## Holbrook Club development – comments from Horsham District Cycling Forum

## Space for Cycling – Quiet links from North Heath Lane and the Holbrook Club to Littlehaven Station

**Figure 1 Jackdaw Lane footpath near the planned foot/cycle exit**

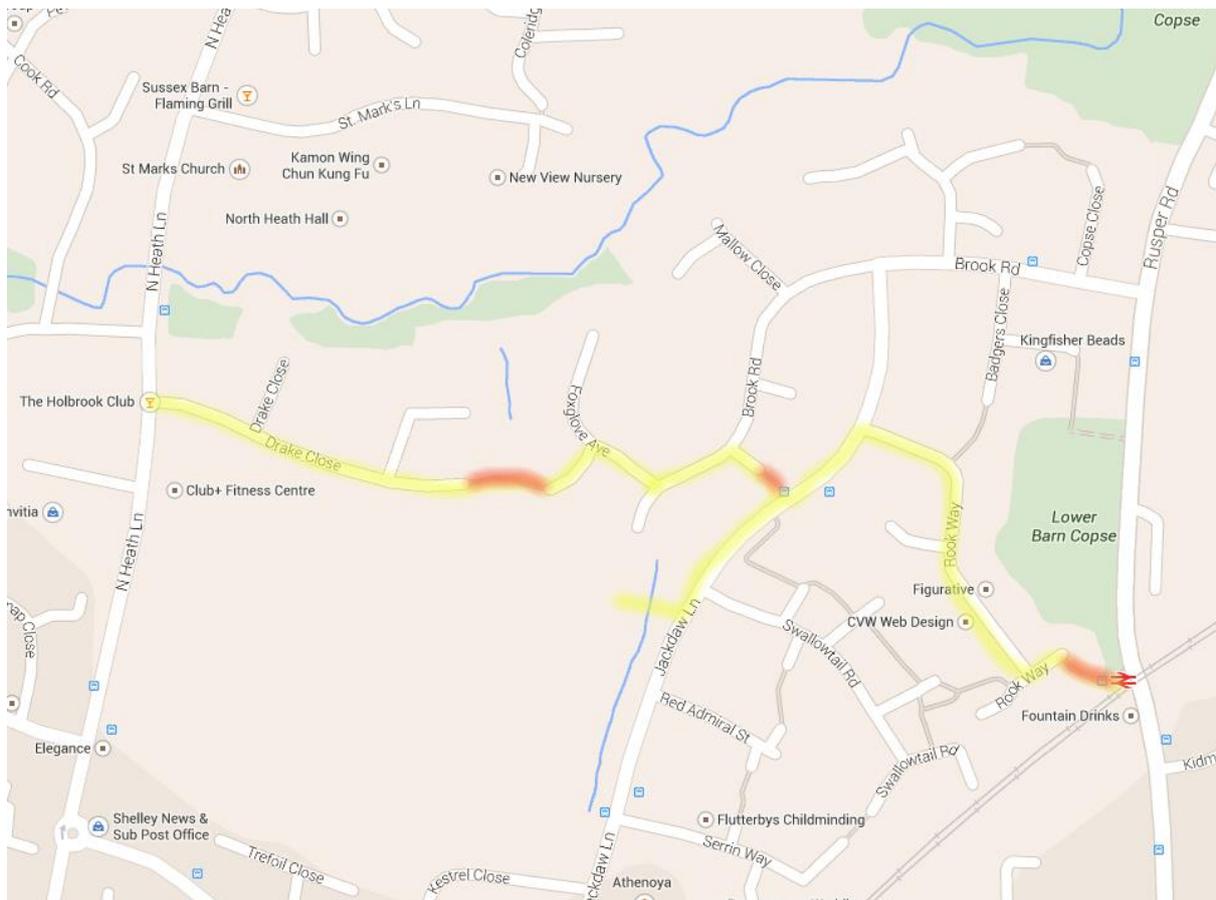
However, the path as shown on the plan ends at the existing footpath on the west side of Jackdaw Lane (see figure 1 below). This means cyclists are expected to ride or walk on the footpath until they can reach the carriageway itself. On the footpath there is a blind corner and overhanging bushes within a short distance of the new development. This is clearly unacceptable as such a design will create conflict between pedestrians and cyclists.

There is plenty of space on the grass to link straight on to the carriageway on Jackdaw Lane. So a good option would be to widen the footpath going north by two metres to create a shared-use path up to the blind corner, where a junction could be created for cyclists to join the road. It would be important for the junction to be well-designed with proper carriageway markings and sensible kerb radii so it is not too tight a turn from Jackdaw Lane. The dropped kerb should be flush with the carriageway at the crossing point.
